Customs Convention on the International Transport of Goods under Cover of TIR Carnets (TIR Convention, 1975):

Revision of the Convention - Amendment proposals for the Convention: Vehicles with sliding sheets

Vehicles and containers with sliding sheets

Note by the secretariat

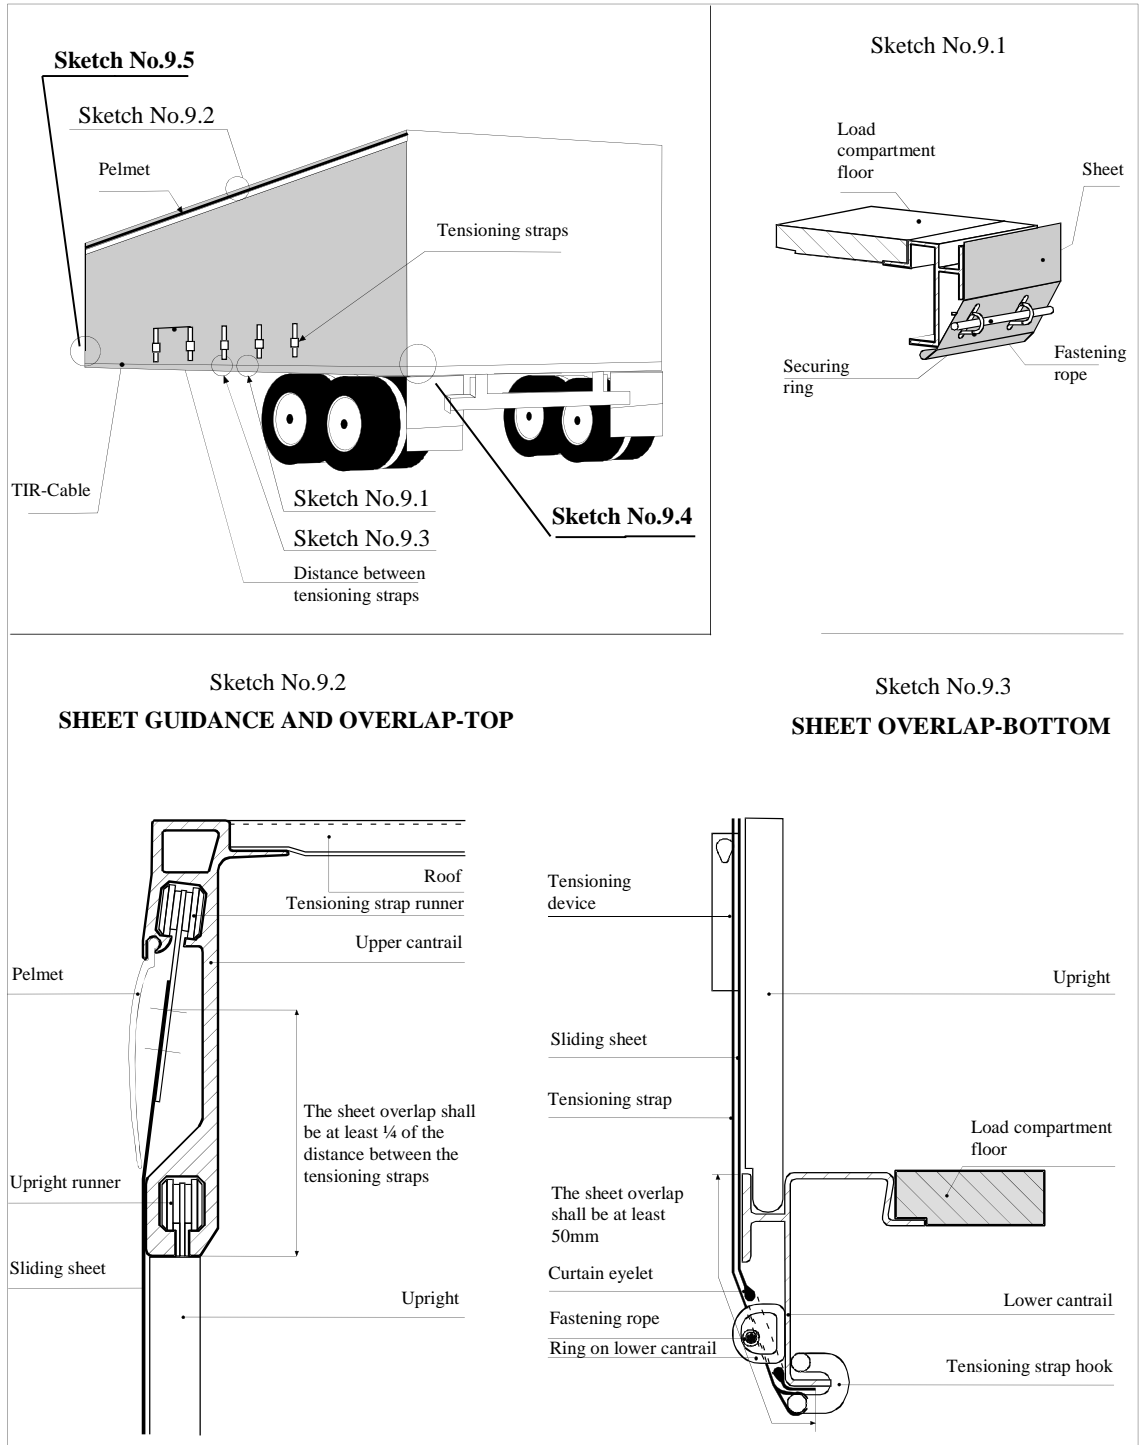
(ii) The sliding roof curtain shall overlap with the solid part of the roof at the side of the vehicle, so that the roof curtain cannot be pulled over the top edge of the upper cantrail. In the hemline of the roof curtain, a pre-stressed steel rope shall be inserted in such a way that it cannot be removed and re-inserted without leaving obvious traces. The roof curtain shall be secured to the sliding carriage in such a way that it cannot be removed and re-secured without leaving obvious traces. The horizontal opening between the sliding roof and the upper cantrail of the load compartment may not exceed 10 mm measured perpendicular to the longitudinal axis of the vehicle at any place when the load compartment is secured and sealed for Customs purposes. The system is described in sketch No. 10 appended to these Regulations.

Sketch No. 9.4

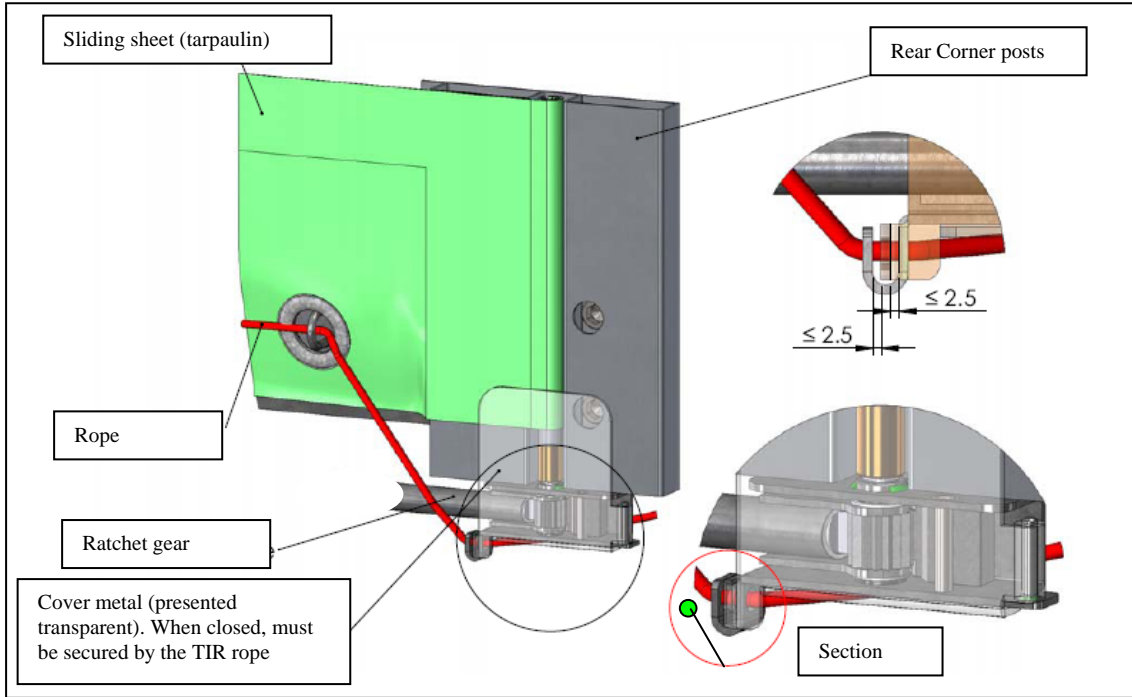
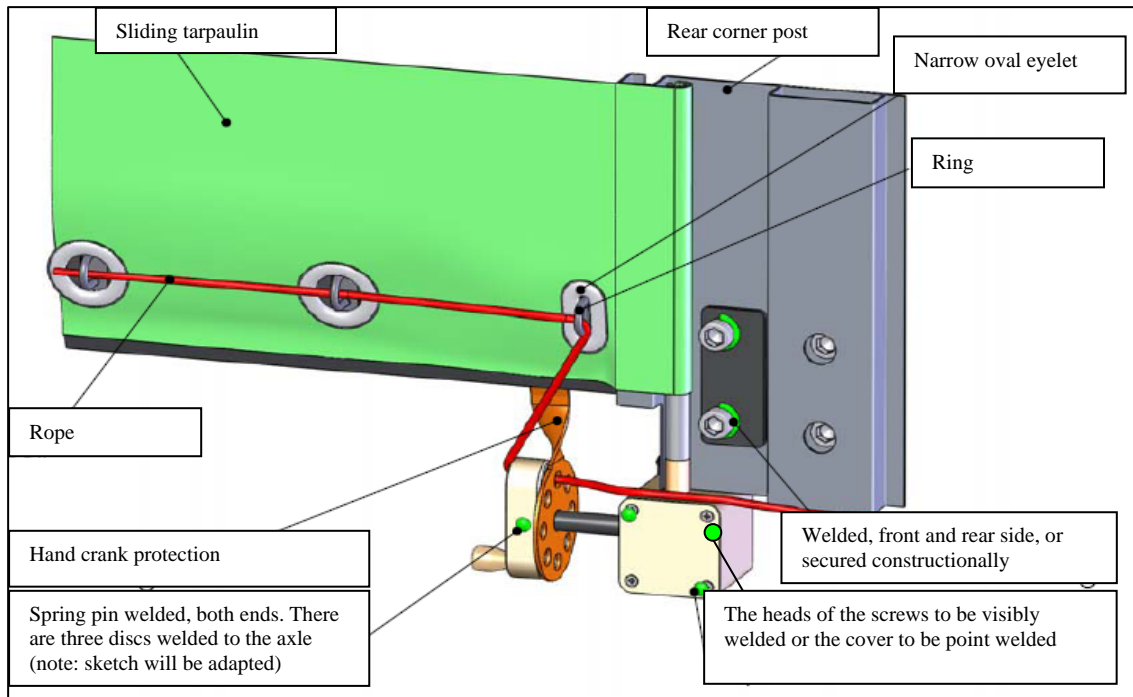
6. Amend Sketch No. 9 as follows:

To tighten the sliding sheets in the horizontal direction, a ratchet gear is used (normally on the rear end of the vehicle). This sketch shows two examples (a) and (b) how the ratchet or gearbox may be secured.

Sketch No. 9.5

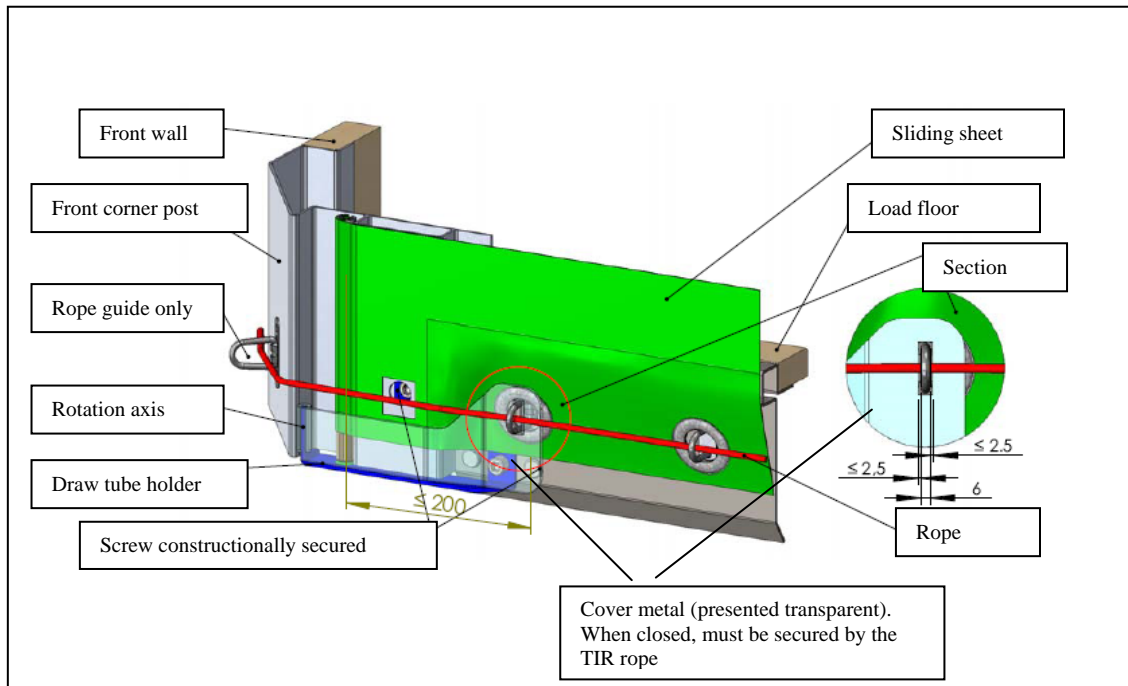
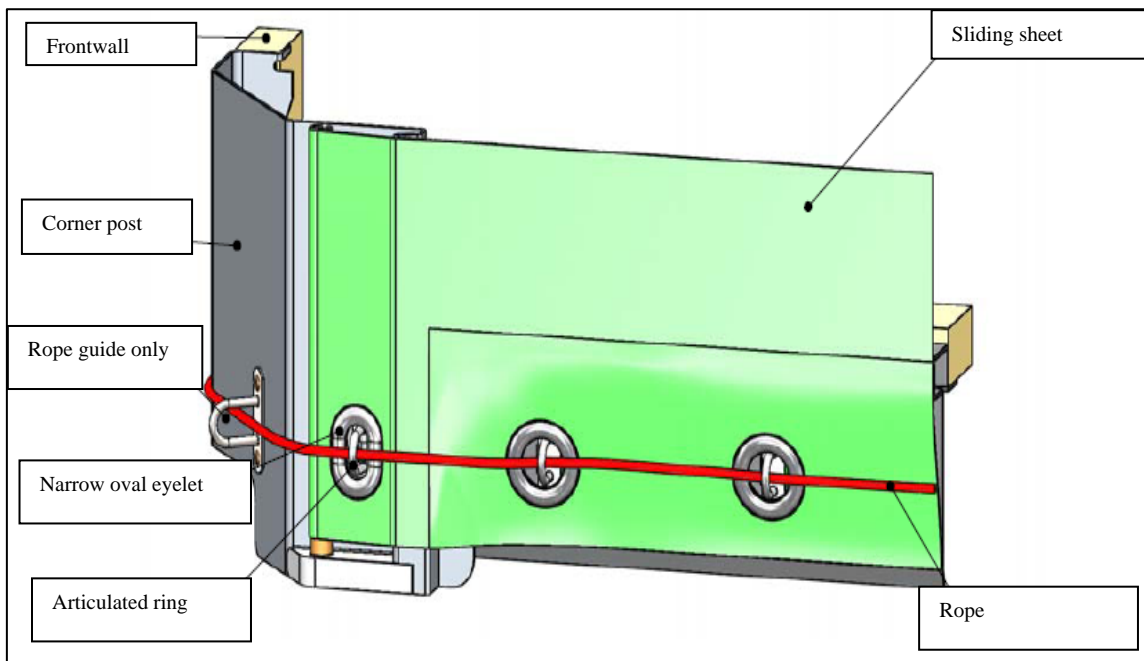
To fix the tarpaulin on the other side (normally to the front of the vehicle) the following systems (a) or (b) may be used.

Sketch No. 10

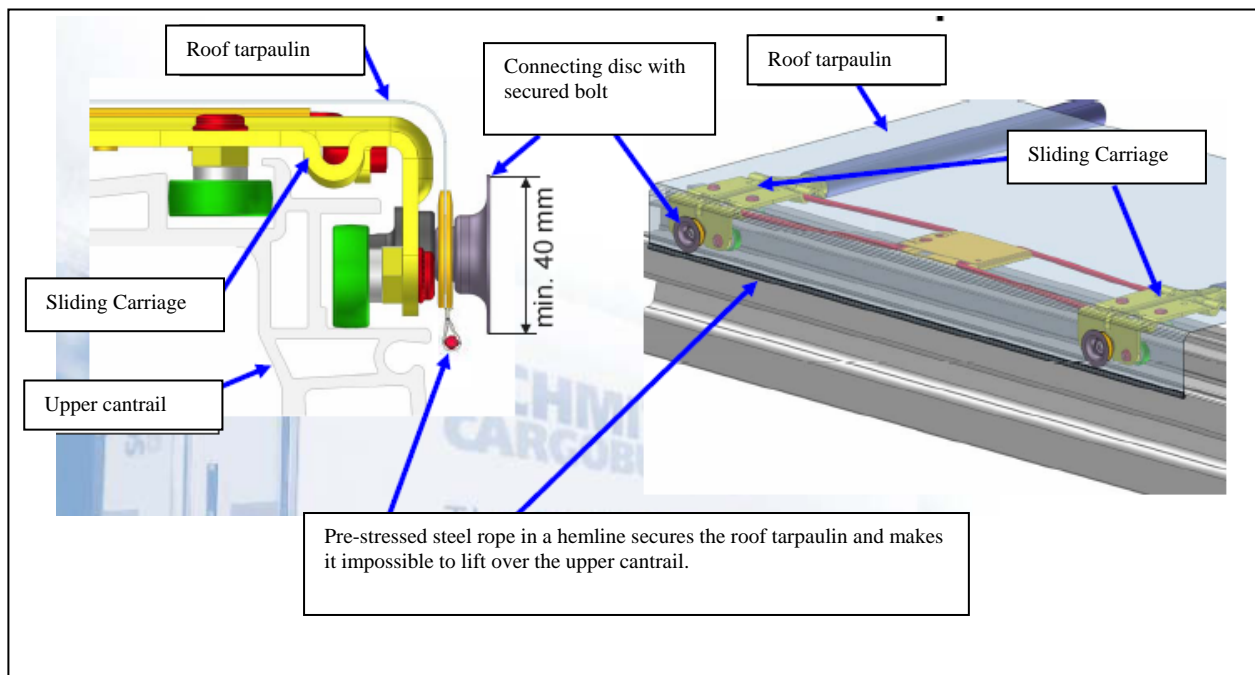
7. After Sketch No. 9, add a new Sketch No. 10:

This sketch shows an example of a vehicle and of important points described within Annex 2, Article 5.

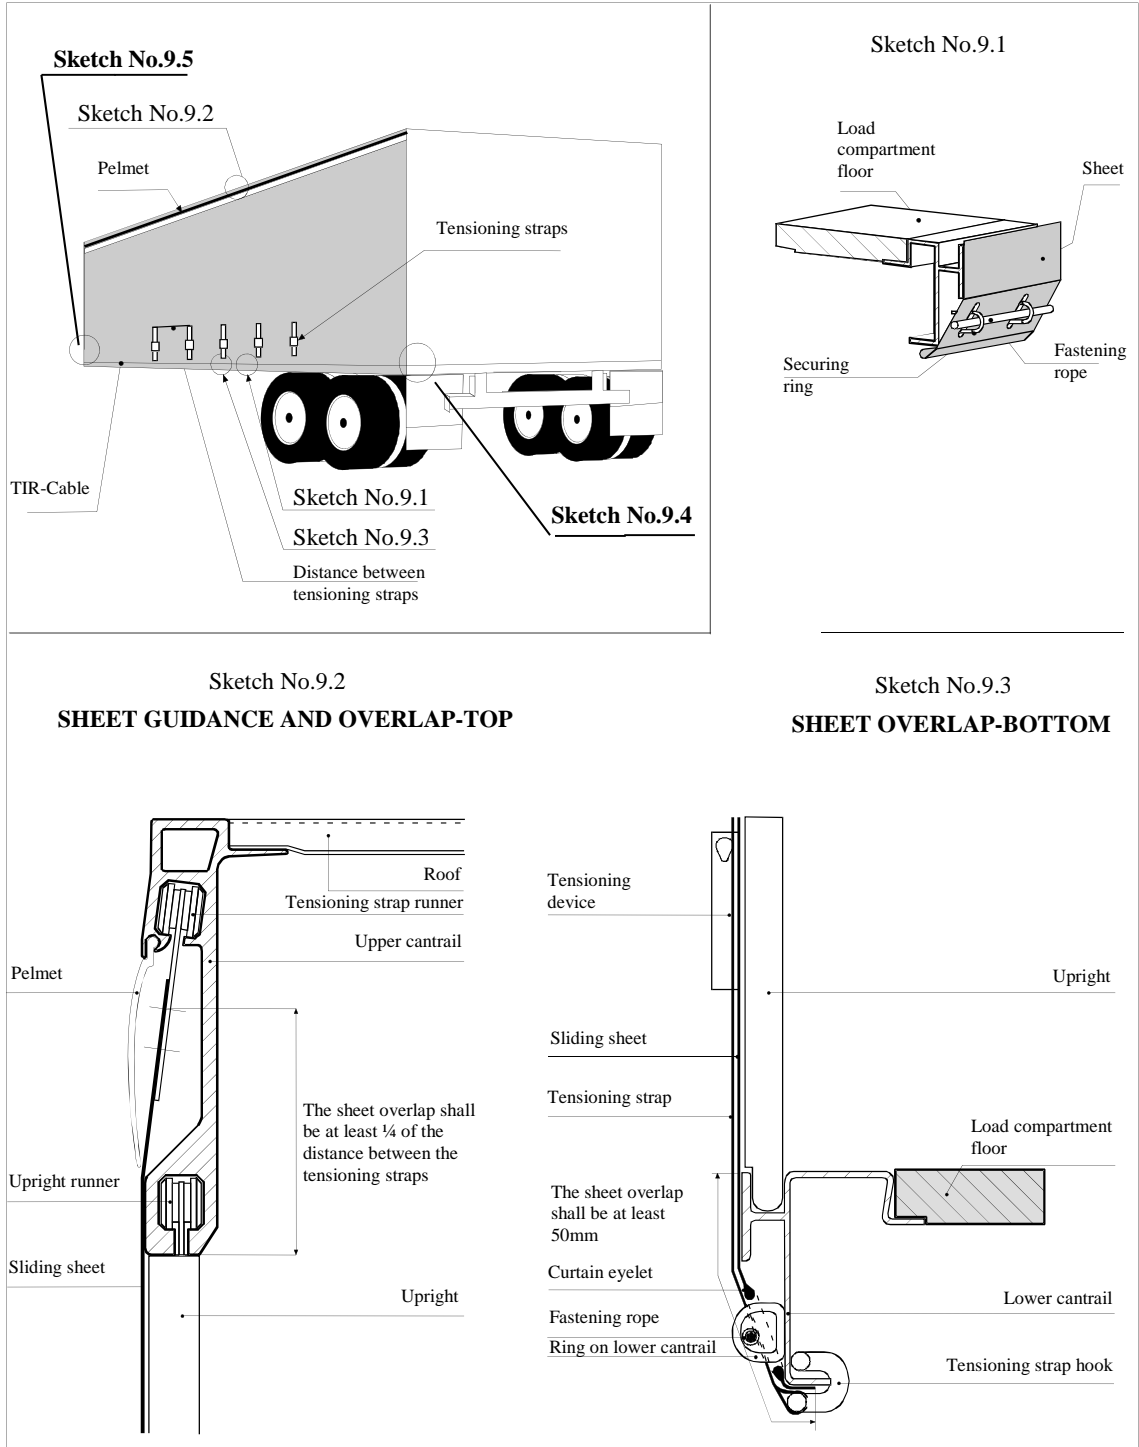
- (ii) The sliding roof curtain shall overlap with the solid part of the roof at the side of the container, so that the roof curtain cannot be pulled over the top edge of the upper cantrail. In the hemline of the roof curtain, a pre-stressed steel rope shall be inserted in such a way that it cannot be removed and re-inserted without leaving obvious traces. The roof curtain shall be secured to the sliding carriage in such a way that it cannot be removed and re-secured without leaving obvious traces. The horizontal opening between the sliding roof and the upper cantrail of the load compartment may not exceed 10 mm measured perpendicular to the longitudinal axis of the container at any place when the load compartment is secured and sealed for Customs purposes. The system is described in sketch No. 10 appended to these Regulations.

Sketch No. 9.4

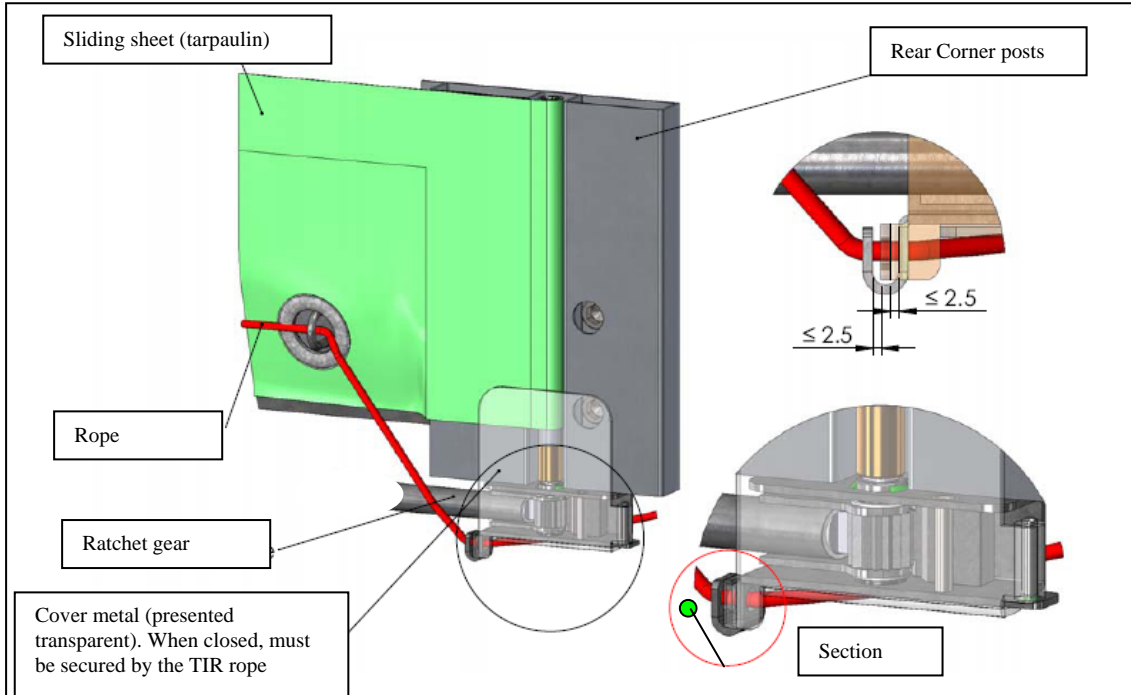
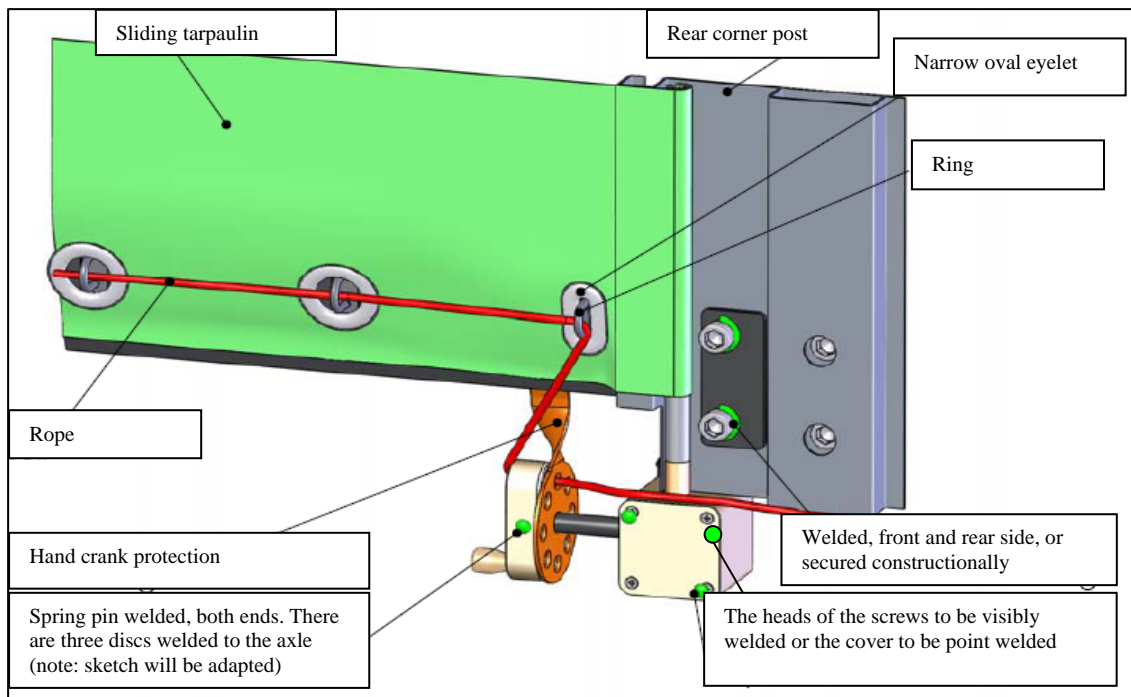
11. Amend Sketch No. 9 to Annex 7 –Part I,

To tighten the sliding sheets in the horizontal direction, a ratchet gear is used (normally on the rear end of the vehicle). This sketch shows two examples (a) and (b) of how the ratchet or gearbox may be secured.

Sketch No. 9.5

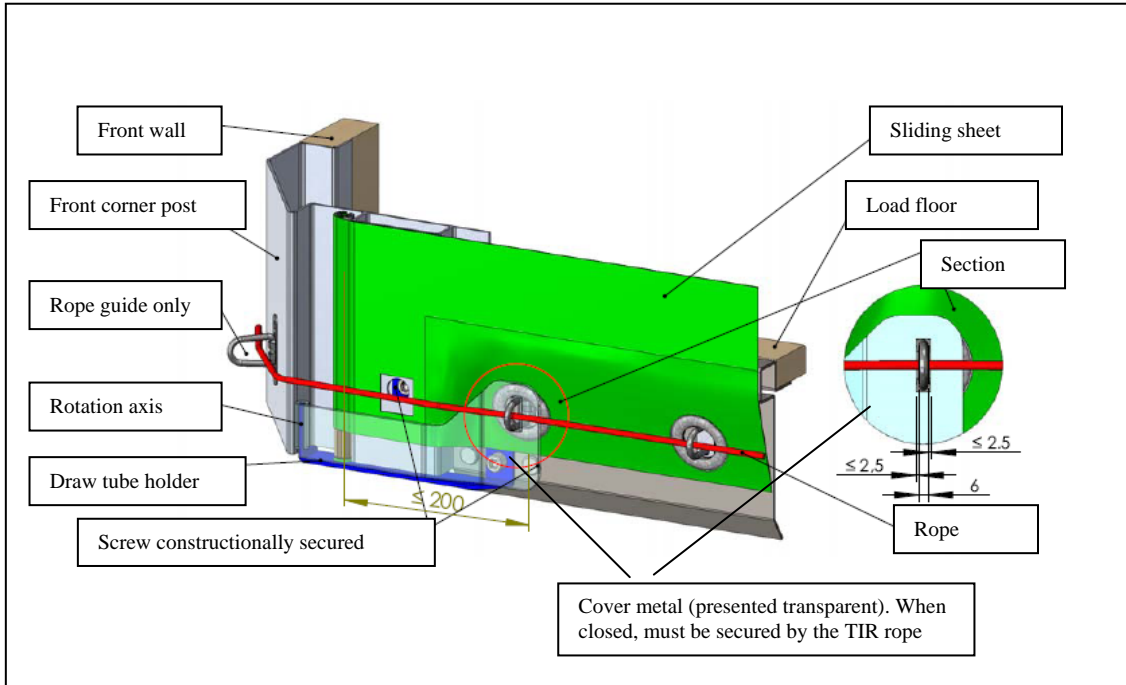
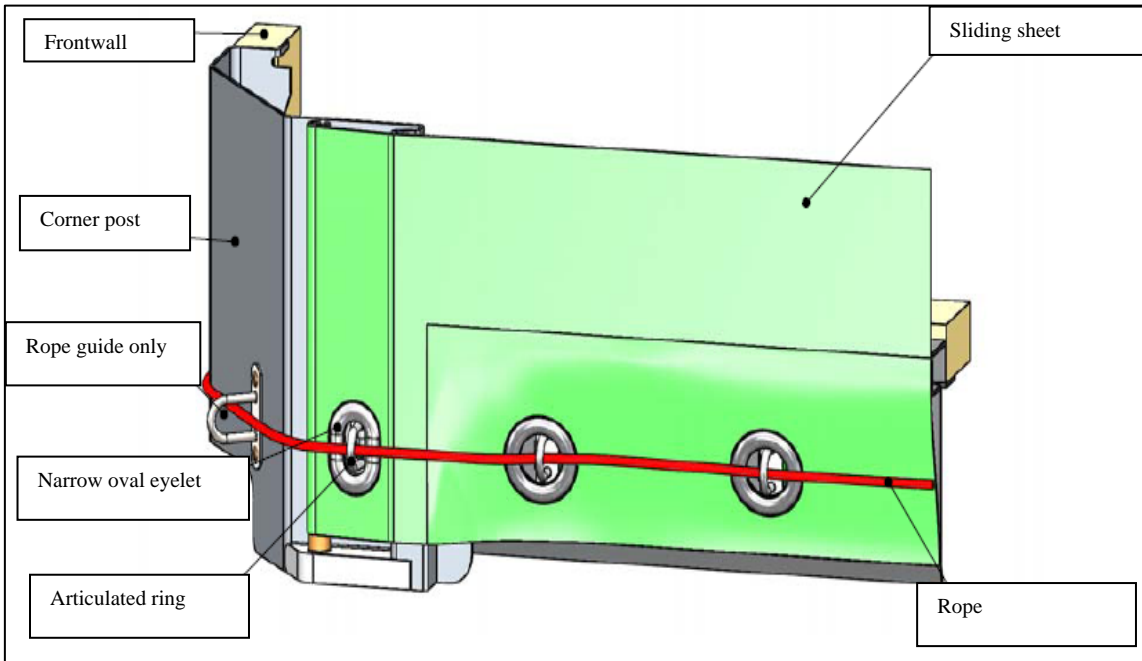
To fix the tarpaulin on the other side (normally to the front of the container) the following systems (a) or (b) may be used.
